# PUBLICATION INDEX FOR SGS 1-36

K & L SOARING, LLC  
5996 STATE ROUTE 224  
CAYUTA, NY 14824

BULLETIN NO. SA-001.6\*

SUBJECT: ONE-TIME INSPECTION OF TOW RELEASE ASSEMBLY; DAILY INSPECTION OF TOW RELEASE ASSEMBLY; PILOT'S PREFLIGHT INSPECTION OF TOW RELEASE ASSEMBLY; 100 HOUR/ANNUAL INSPECTION OF TOW RELEASE ASSEMBLY.

FIGURE 3

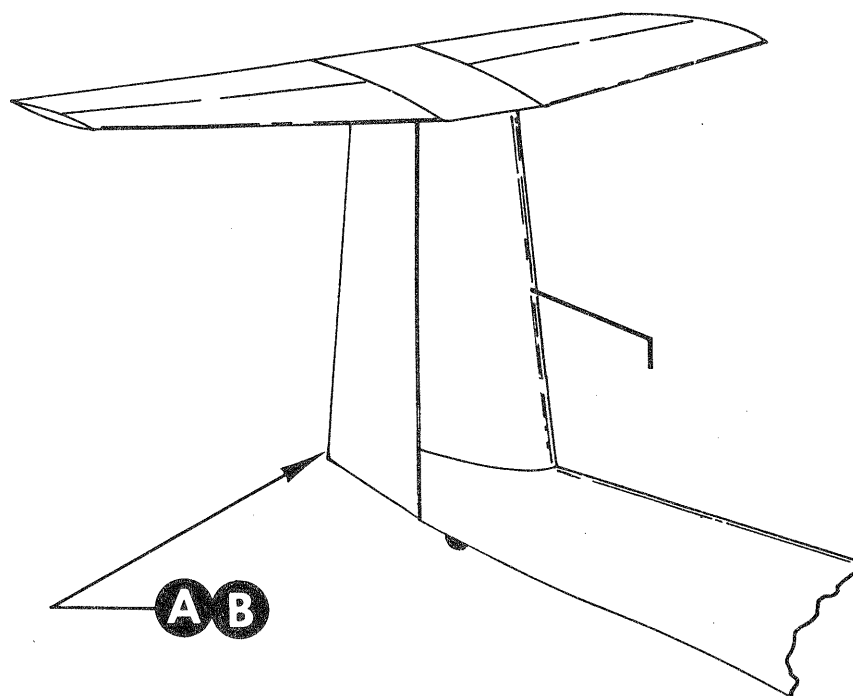
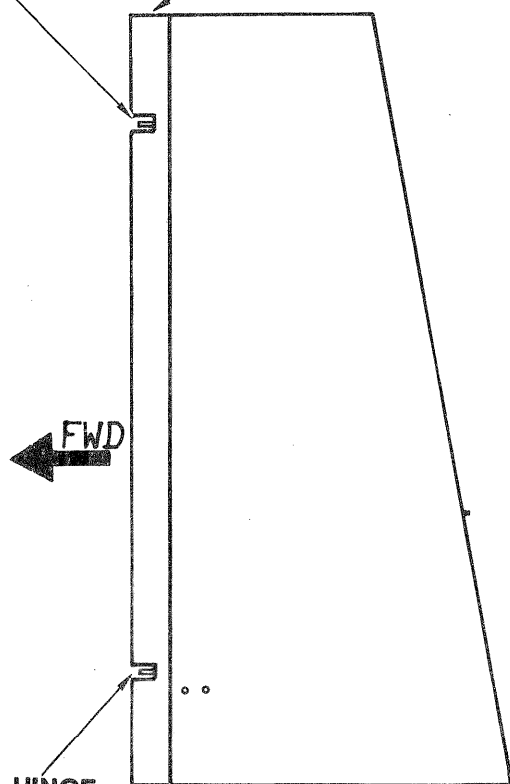
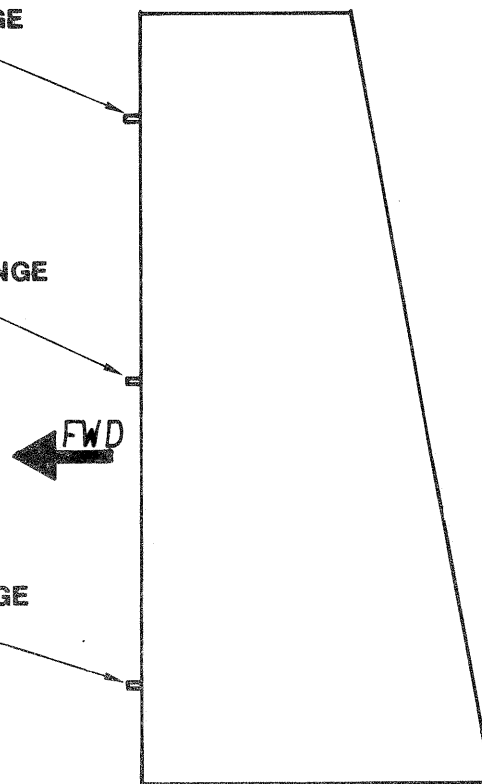
One of two types of tail rudders may be installed on the affected aircraft. The earlier type is an unsealed unit without a leading edge fairing (Figure 3, Detail B). The later type is sealed at the leading edge by a fairing (Detail A). Removal of an unsealed rudder is accomplished by performing step a(1) through a(3). A sealed rudder is removed by performing steps b(1) through b(3).

- a. If an unsealed rudder (Figure 3, Detail B) is installed, remove rudder as follows:
  - (1) Peel off gap tape between rudder and tail fin.
  - (2) Disconnect pushrods at lower end of rudder by removing a cotter pin, nut, washer and bolt from each push rod.
  - (3) Remove cotter pin, nut, and washer from upper, middle and lower hinge bolts at forward end of rudder. Remove hinge bolts.
  - (4) Remove rudder by sliding aft.
- b. If a sealed rudder (Figure 3, Detail A) is installed, remove rudder as follows:
  - (1) Remove cotter pin, nut, and washer from upper hinge bolt. (Do not remove bolt.)
  - (2) Remove four screws securing lower end of rudder.
  - (3) Remove rudder by pulling lower end aft and then sliding rudder upwards off hinge bolt.

- c. Using a flashlight and inspection mirror, inspect for debris inside of rudder by looking through hinge openings (Figure 3, Detail A or Detail B, as applicable).
- d. If debris is noted between leading edge fairing and spar, remove debris through upper hinge opening, using vacuum cleaner and flexible extension hose.

FIGURE 4.

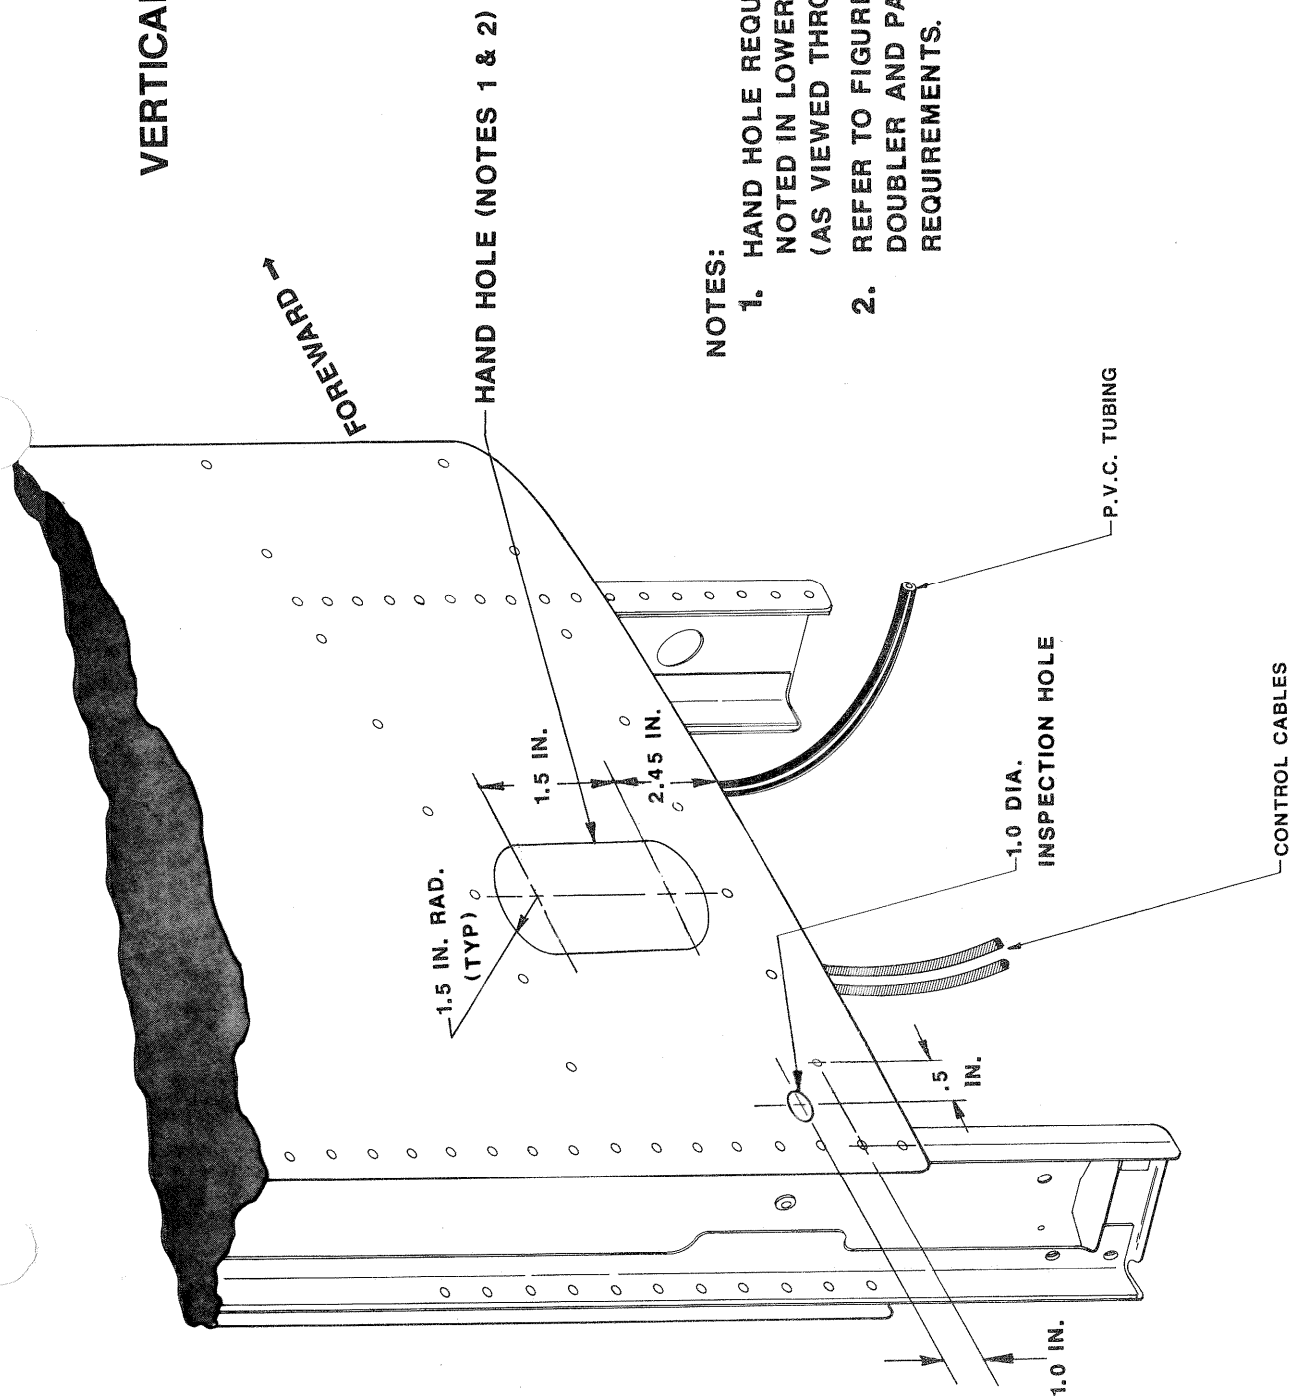
- j. Remove oval shaped inspection holes at aft end of fuselage and inspect fuselage interior for debris. Remove debris as required.
- k. Using 1-inch drill bit and drill, install a 1-inch inspection hole in one side of tail fin at location shown in Figure 4.

- (1) Use drill to puncture skin (of tail fin) and saber saw (or equivalent) to cut access hole at location shown (and size shown) in Figure 4. Deburr edges of access hole.

1. HAND HOLE REQUIRED ONLY IF DEBRIS IS NOTED IN LOWER PORTION OF TAIL FIN (AS VIEWED THROUGH INSPECTION HOLE).
2. REFER TO FIGURE 5 FOR STRUCTURAL DOUBLER AND PATCH INSTALLATION REQUIREMENTS.

FIGURE 5. STRUCTURAL DOUBLER ID PATCH

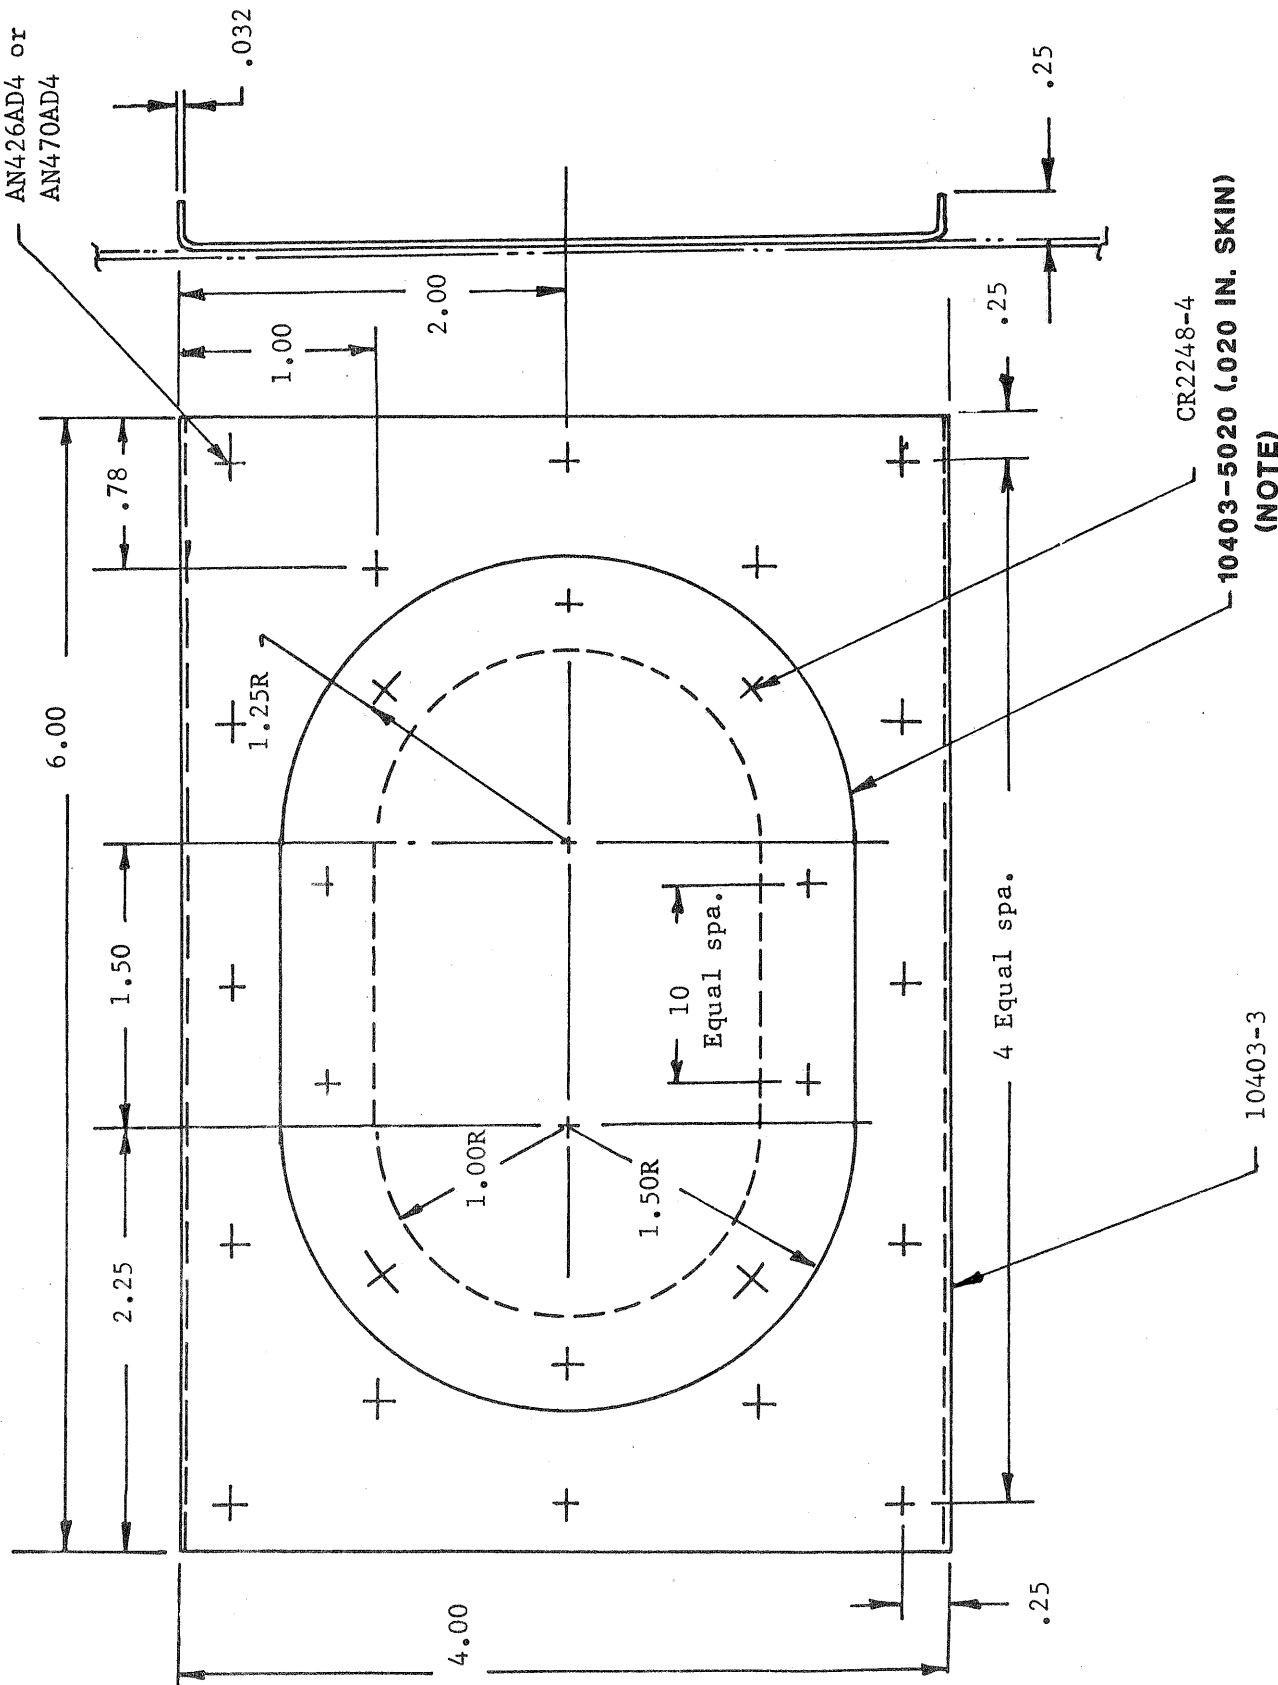
- (2) Use vacuum cleaner with flexible extension hose to remove debris from lower portion of tail fin.
  - (3) Using doubler as a template, install appropriate number of rivet holes (of proper size) in tail fin skin at locations shown in Figure 5.

- (4) Slide doubler through access hole, rotate it 90 degrees, and use appropriate rivets (Figure 5) to fasten doubler to fin skin.
  - (5) Secure patch to doubler with rivets. (Refer to Figure 5.)

Doubler  
.032 2024-T3 Alc.  
NOTE: EARLY SGS 1-35 SAIL PLANES WHICH INCORPORATE  
A .016 IN. SKIN REQUIRE A 10403-5016 PATCH.
